NOTICE OF MEETING
PLANNING AND ZONING COMMISSION
6:00 P.M. – July 16, 2020

PLANNING AND ZONING COMMISSION ITEM:
PC-20-08
FINAL PLAT
4S RANCH, UNIT 7C

SUBJECT: 4S Ranch, Unit 7C Final Plat Acceptance
 PC-20-08

REVIEW MEMORANDUM

MATCHLINE "H" - SEE SHEET 5 OF 6

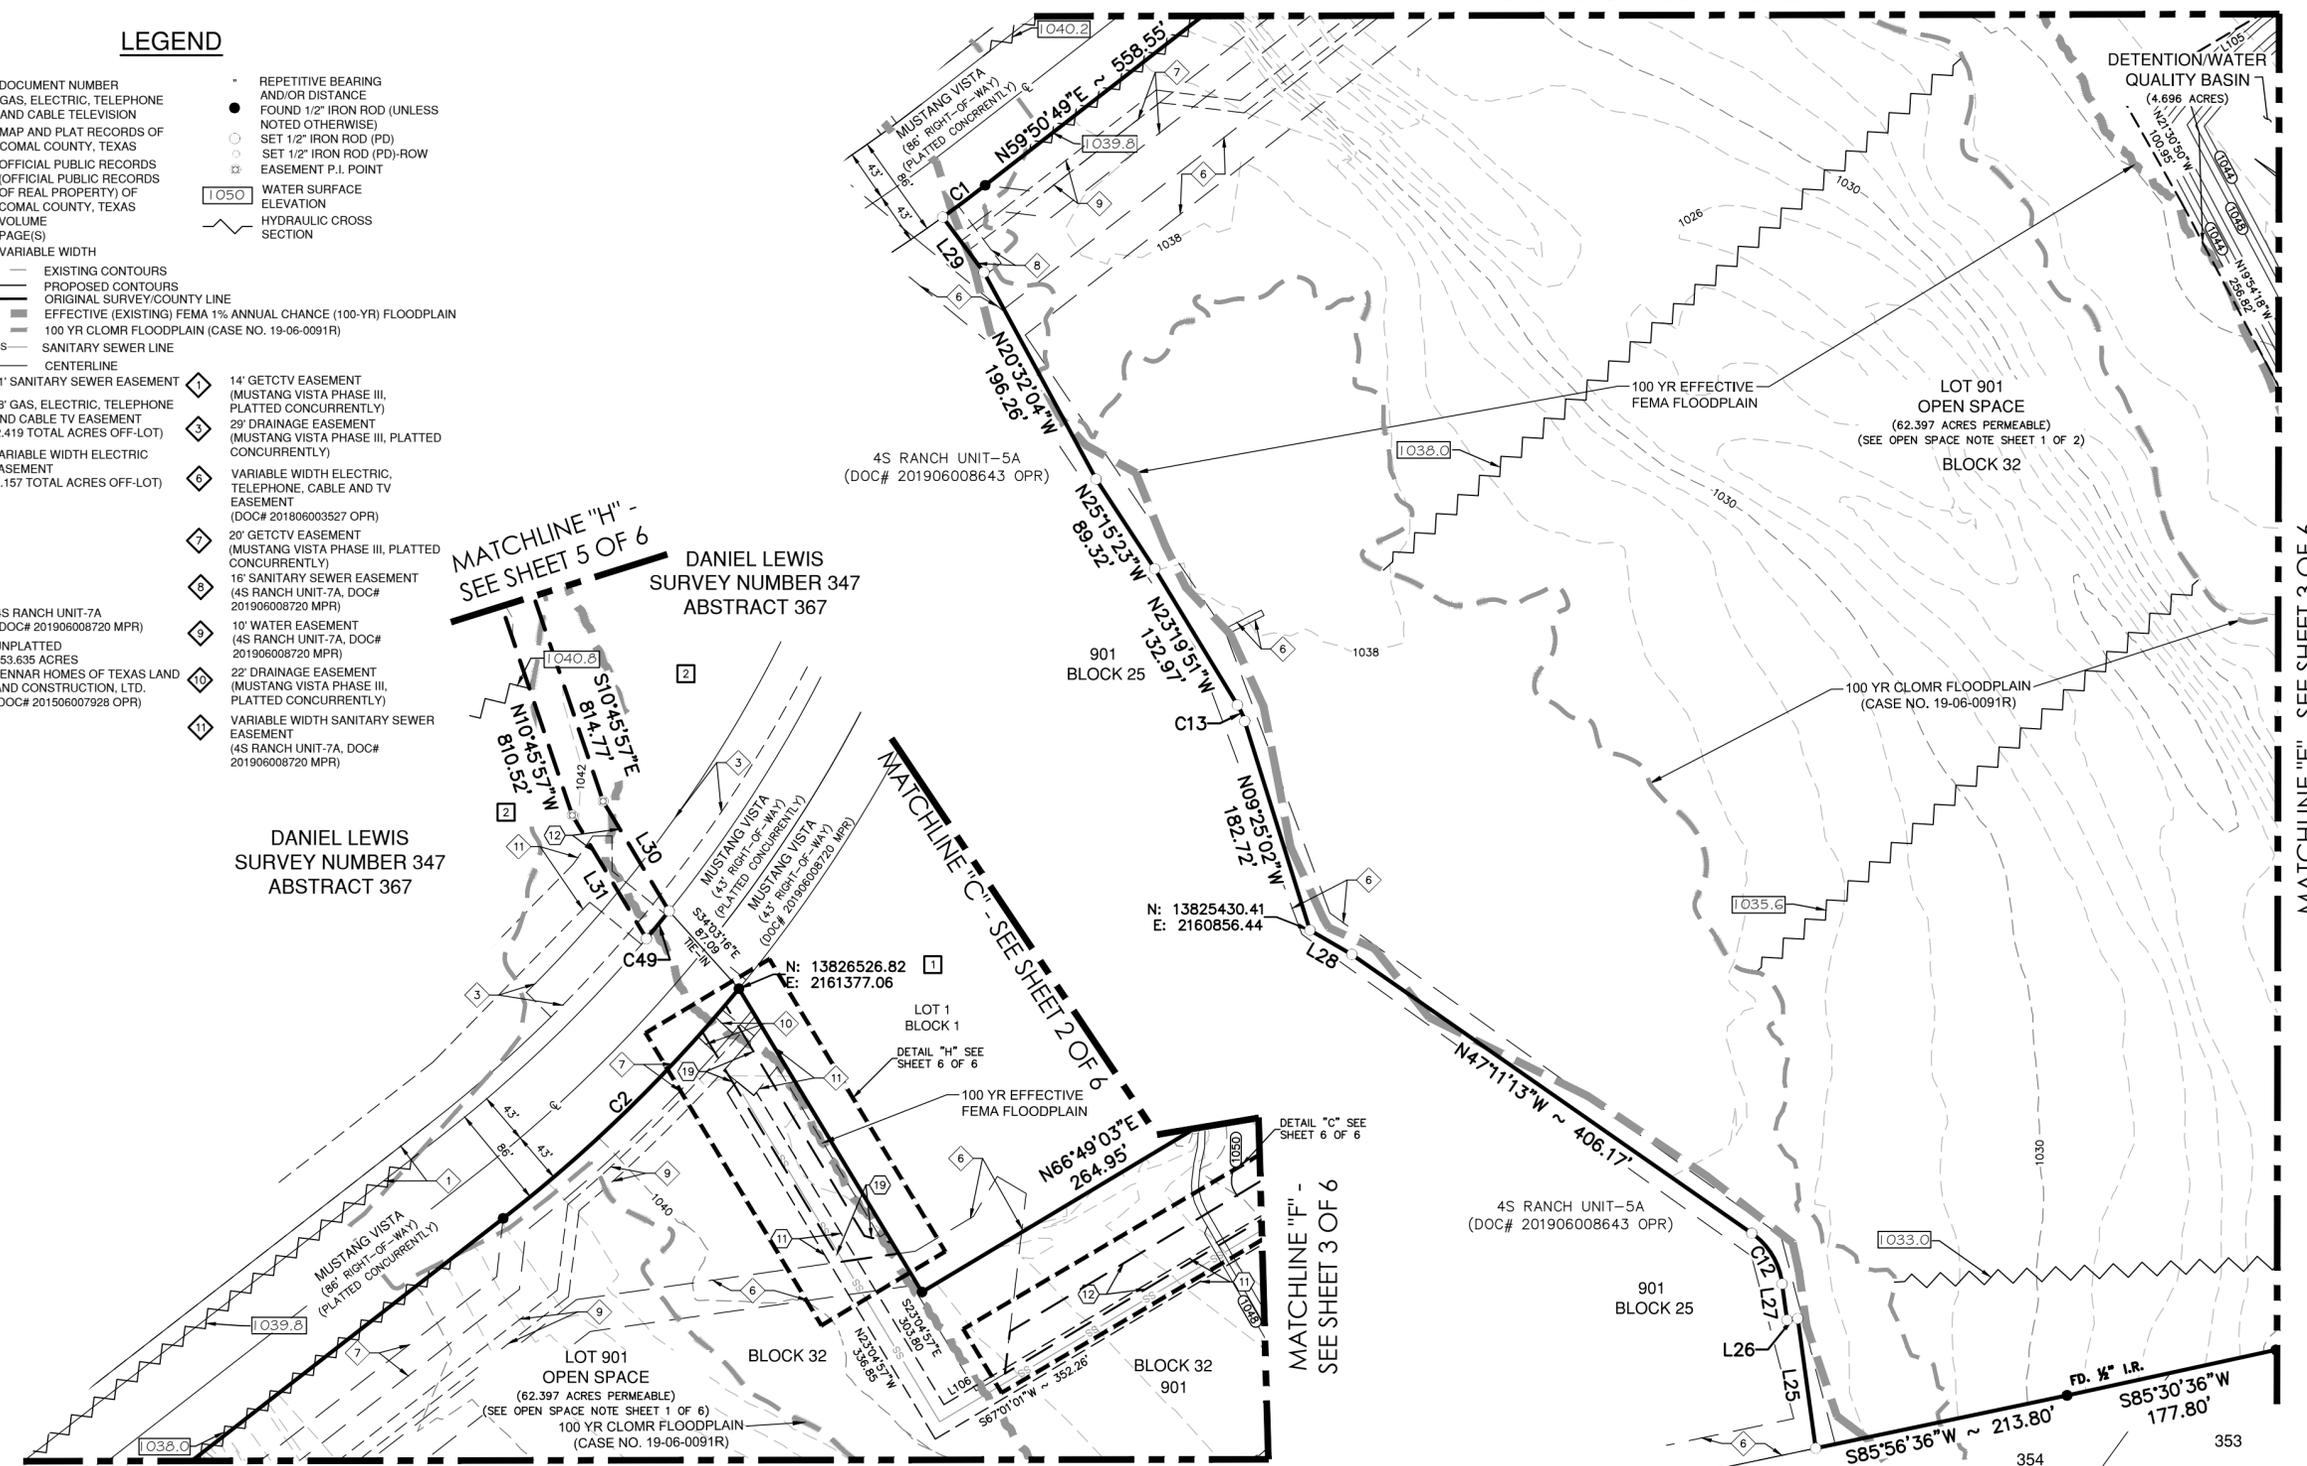
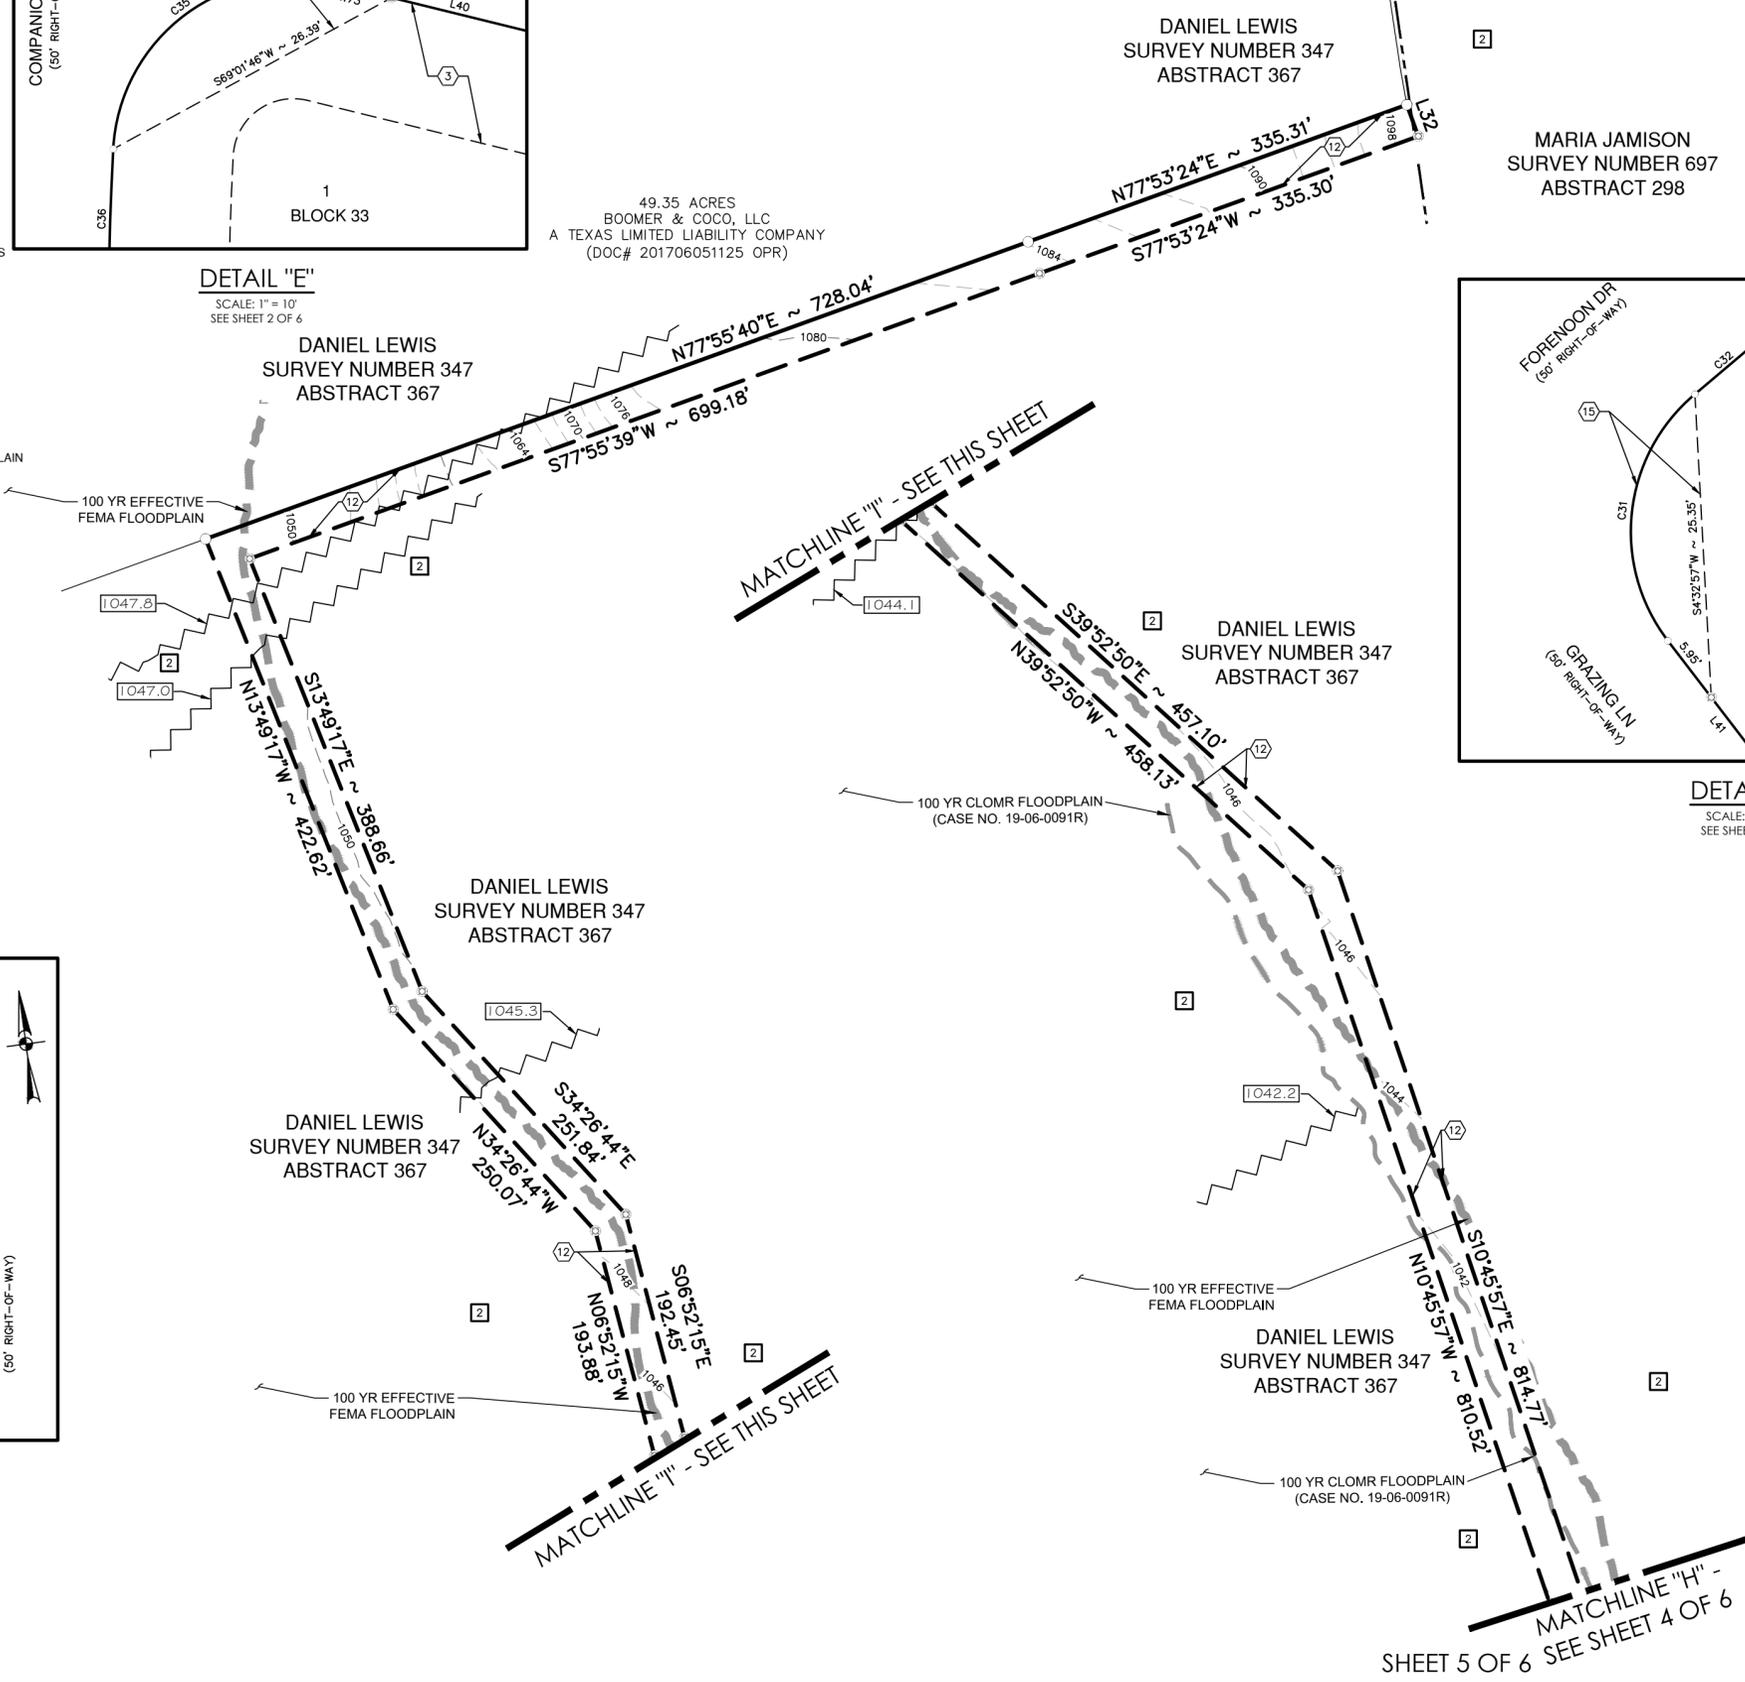
- Legend on several sheets refers to Mustang Vista Phase 3 being platted concurrently. This plat was recommended for approval on June 28, 2019. Please include the Doc # similar to other easements in the legend. – *Comment withdrawn...although already accepted by P&Z, the Mustang Vista Phase III plat has not yet been recorded. No document number is available and the 'PLATTED CONCURRENTLY' text is still appropriate.*

Response: Please note that although accepted by P&Z, the Mustang Vista Phase III plat has not yet been recorded. Therefore, no document number is available for the plat. The 'PLATTED CONCURRENTLY' text is to be replaced upon recordation of the plat.
